RESPONSE TO SUBMISSIONS AND FURTHER ADVICE LETTER - PROPOSED MULTIPLE DWELLING (34 DWELLINGS)

239 & 241 Boundary Street, Coolangatta

Council ref: MCU/2023/15

Figure 2: Annotated Elevation

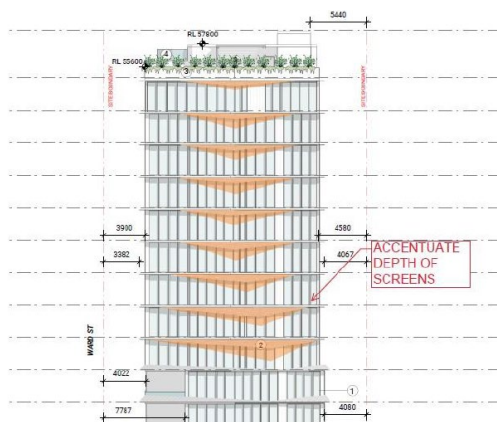
- f. To further assist with the reduction in the extent of sheer glazing, noting that building recesses are unlikely to be achievable due to the tight floor plates, officers recommend emphasising the batten feature screen to the south-east elevation and shading feature to the north-west elevation, for movement, shadow play and visual interest. This may be achieved by accentuating the depth of the vertical point as it moves across the façade at each floor level as per the mark up below.

RESPONSE: As discussed, and previously presented to officers, items ‘a’ through ‘f’ have all been addressed and the requested changes are reflected on the **Amended Architectural Plans (Appendix D)**.

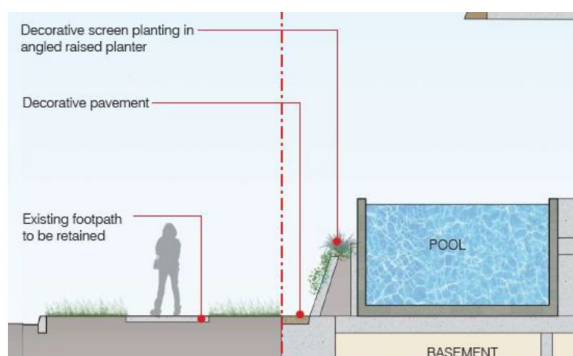
- a. The current proposal includes what appears to be sheer glazing for the full extent of the Level 7 to level 14 facades where previously solid concrete vertical textured panels were proposed which provided a balance to the composition, additional visual interest and a break in the extent of sheer glazed façade. Officers recommend that these solid textured panels are retained (shown on the elevations, not perspectives) to reduce the commercial glazed appearance and reinforce local identity and sense of place with a residential appearance (north-west, north-east, south-east elevations).*

- b. The previous proposal included solid concrete vertical textured panels to the north-east elevation to both the recess and either side of the lift core. Officers recommend that these solid textured panels are retained (shown on the elevations, not perspectives).*

- c. The previous proposal included planters for the full height of the tower to the north-east elevation. Officers recommend that these planters are reinstated.*

- d. The previous proposal included corner glazing with no mullions which reduced the boxy, rectilinear appearance of the upper levels where there is no balcony to lighten the appearance of the building edges. Officers recommend re-introducing this high-quality detail.*

- e. The previous proposal included texture to the balcony soffits (timber look or similar) however the proposal now appears to include a flat paint finish. Officers recommend re-introducing this high-quality detail.*

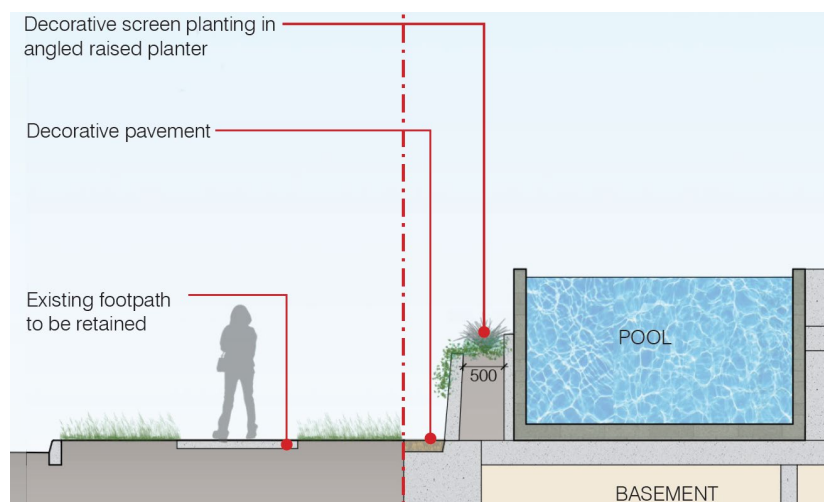
The applicant has provided amendments to the frontage landscaping beds to provide a consolidated planting area. Officers note that the decorative paving on the south western boundary adjacent the pool results in a planter width pinch-point of less than 400mm (below image). The applicant is requested to adjust the angle of the angled raised planter to provide a wider planting surface area with a minimum width of 400mm excluding the planter box walls.

RESPONSE: As shown in the **Amended Landscape Plans (Appendix E)**, the identified planter has been adjusted to achieve a width of 500mm not including the planter box walls.
